DELEGATED OFFICER REPORT

WOKINGHAM
BOROUGH COUNCIL

Application Number:	261598
Site Address:	127 Wilderness Road, Earley, Wokingham, RG6 5RD
Expiry Date:	11 September 2026
Site Visit Date:	17 August 2026
Proposal: Householder application for the proposed erection of first floor pitched roof rear extension following removal of existing first floor flat roof areas, 2no. Chimneys and side dormers plus removal of part of the existing garage. Installation of solar panels and rooflights.

Figure 1 Proposed lighting to garage

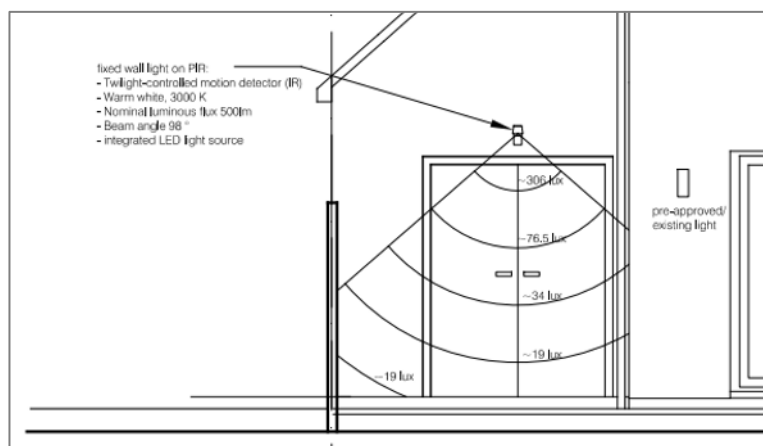
3. *No new external lighting shall be installed on the dwelling or within the site unless details of its position, design, luminance, light spill and hours of operation have first been submitted to and approved in writing by the local planning authority. Any lighting shall thereafter be installed and operated only in accordance with the approved details.*

Reason: To avoid illumination of bat roosting features and retained boundary vegetation and thereby minimise disturbance to protected species, in accordance with Core Strategy Policies CP3 and CP7 and MDD Policies CC03 and TB23.

Officer comment: that Revised plans have been submitted with details of the position, design, luminance, light spill and hours of operation of the 1 no. additional light to be

installed on the rear elevation and above the garage door. Figures 1 and 2 show that sufficient details have been supplied. Therefore, a lighting condition is not necessary.
